JOINT REGIONAL PLANNING PANEL
(Northern Region)

JRPP No	2016NTH009
DA Number	DA16/0056
Local Government Area	Tweed Shire Council
Proposed Development	<p>Concept Development Application under Section 83B of the EP&A Act 1979 for the development of Precincts 6, 7, 8, 9, 10, 11 & 12 – Cobaki Lakes (JRPP), Stages 2 and 3 – Subdivision of part Precinct 6 and part Precinct 7 comprising 452 residential lots, 8 public open space lots, 1 school lot, residual lots and associated infrastructure.</p> 
Street Address	Lots 46, 54, 55, 200, 201, 202, 205, 206, 209, 199, 228, 305 DP 755740; Lot 1 DP 823679; Lot 1 DP 570077; Lot 1 DP 562222; Lot 2 DP 566529; Lot 1 DP 570076; Sandy Lane and Piggabeen Road, Cobaki Lakes
Applicant	LEDA Manorstead Pty Ltd C/- Planit Consulting Pty Ltd
Owner	LEDA Manorstead Pty Ltd
Number of Submissions	<p>Nil public submissions were received.</p> <p>Submission have also been received from/on behalf of the following Public Authorities:</p>

Assessment Report and Recommendation

FILE NO: DA16/0056

Figure 9 – Plan 6400-308 residue lot subdivision of Precincts 6 & 7 created by the Project Approval subdivision

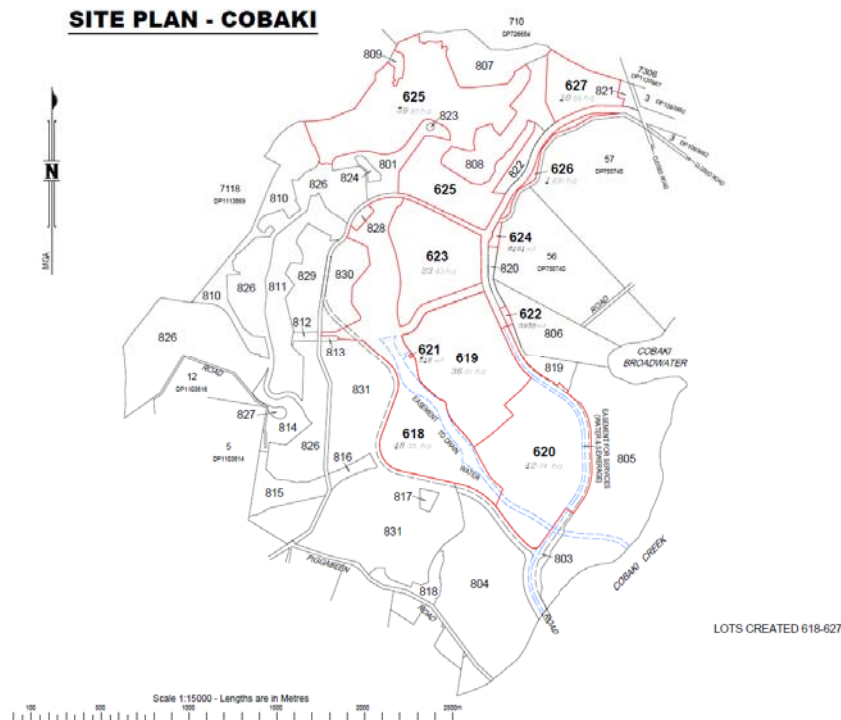
It is noted that plan below does not include the separate allotments for sewer pump stations, stormwater bioswales etc. The applicant has acknowledged that Plan 6400-308 will need to be amended to reflect these additional allotments.

It is considered that the abovementioned subdivision sequencing will create the appropriate separate allotments for land zoned Environmental Protection (i.e. not for agricultural or residential purposes), thereby satisfying the provisions of Clause 20.

Figure 12 – Details for Bio Basins E, F and G

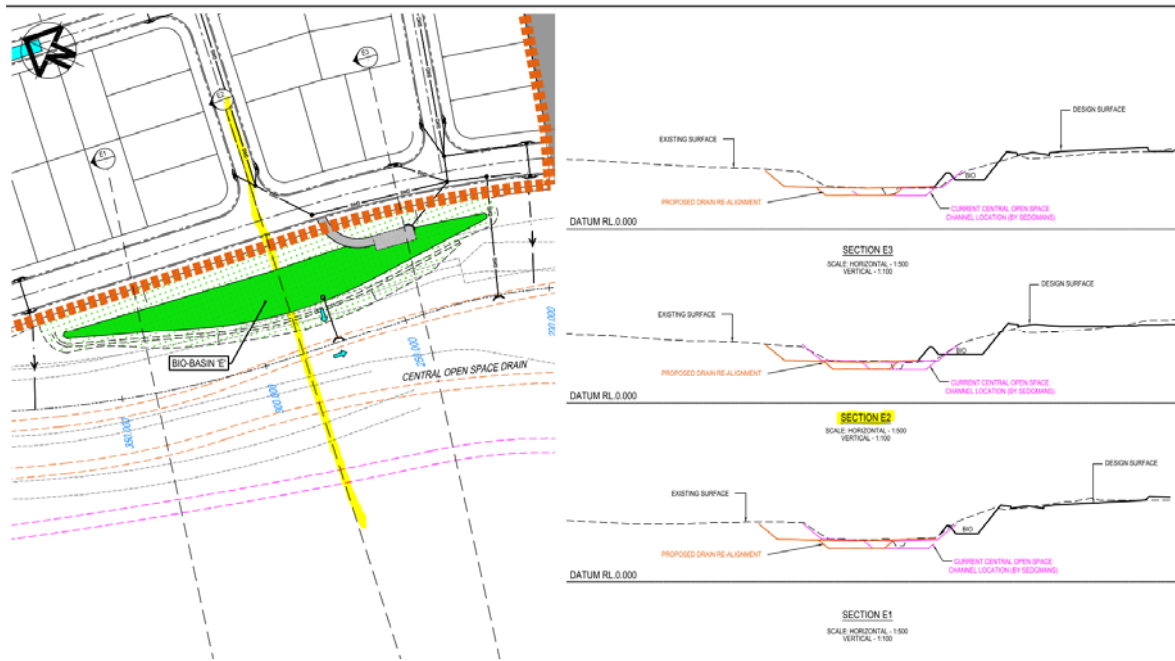
As noted previously, Council officers have had several discussions with the applicant with regard to the stormwater design. In order to accommodate proposed Bio Basins "E", "F" and "G" (shown in Figure 12 below) within the Central Open Space (COS), the Construction Certificate of the COS (C107 from Private Certifier) will have to be amended.

Council's Development Engineer considers this scenario to be acceptable and an appropriate condition has been applied, including the requirement for an updated hydraulic (flooding) assessment of the COS which considers the additional works within the COS.

Figure 17 – Proposed Road Type Locations

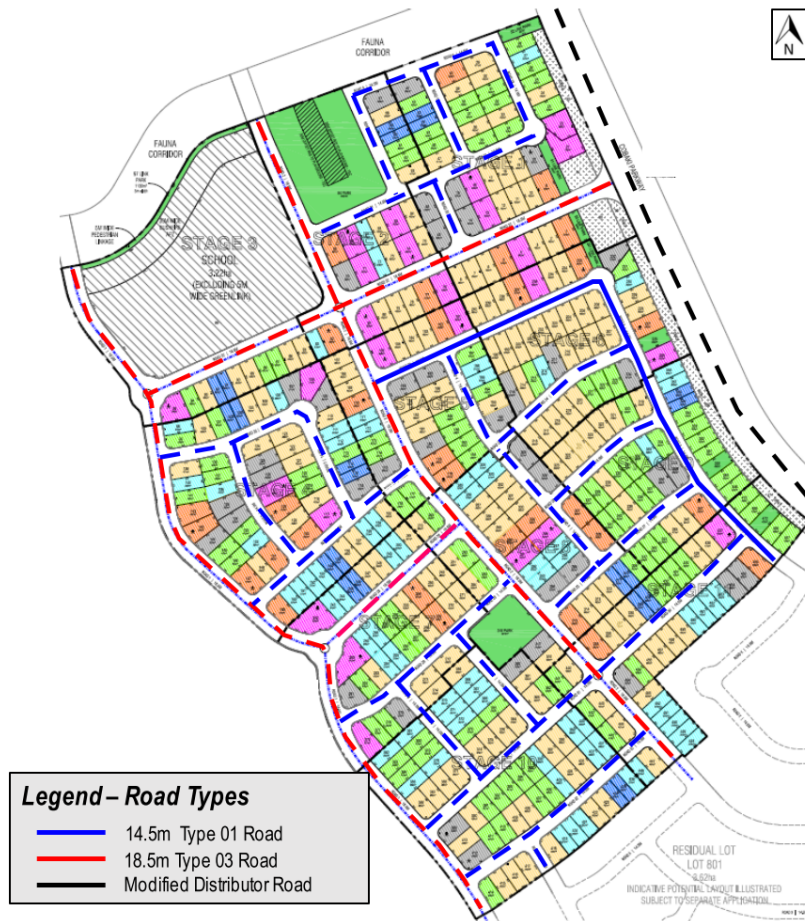
Council’s Development Engineer has noted that the most recent TIA is not consistent with the latest subdivision design (i.e. revised configuration to provide for the required stormwater treatment and the cul de sac in Stage 2 of the development). An appropriate condition has been applied in this regard.

Figure 18 – Precinct 6 & Cobaki Parkway Intersection Design

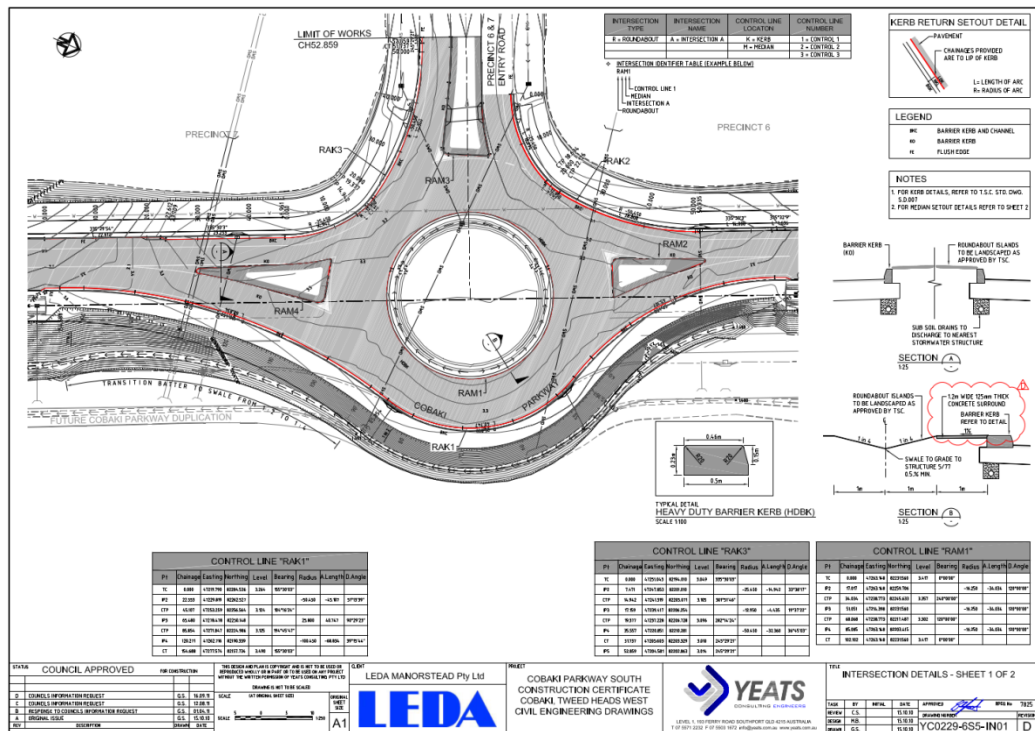
As requested in Council’s initial RFI letter, a new intersection (4 way with roundabout) was added at the intersection of Road 02 and Road 31 to achieve compliance with Section D1.07 of Council’s Development Design Specification D1 – Road Design, which stipulates that where Neighbourhood Connector Roads exceed 600m in uninterrupted length, additional speed control is required.

Figure 27 – Recommended Acoustic Barrier Treatment

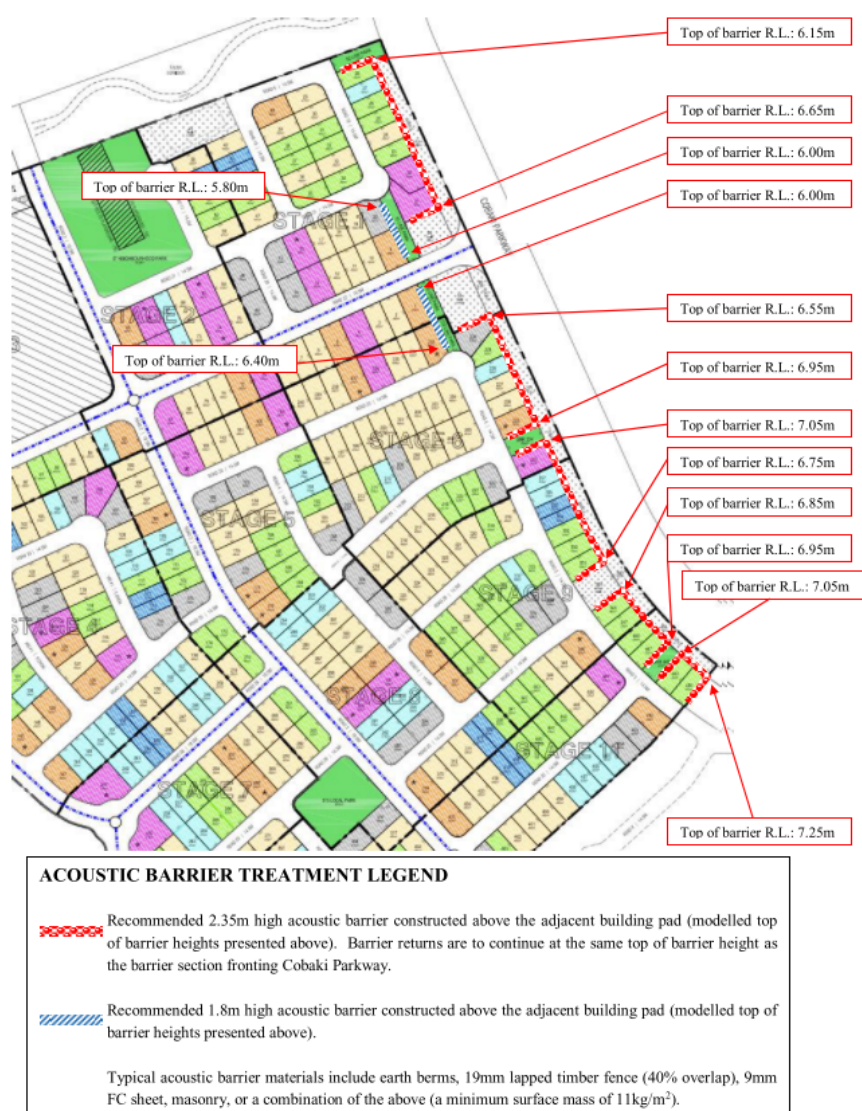
The Report recommends the provision of 2.35m high acoustic barriers along the rear (and some side) boundaries of allotments adjacent to the Cobaki Parkway (as shown in Figure 27 below). The Report also recommends a 1.8m high acoustic barrier for four allotments along Road 22 (near the intersection with Cobaki Parkway).

The Report requires the owners of the allotments along the Cobaki Parkway to provide a separate detailed noise assessment (once dwelling designs have been finalised) for dwellings incorporating above ground floor levels to determine specific building shell treatments of the proposed habitable rooms, as per the internal noise criteria provisions of Australian Standard 3671:1989.
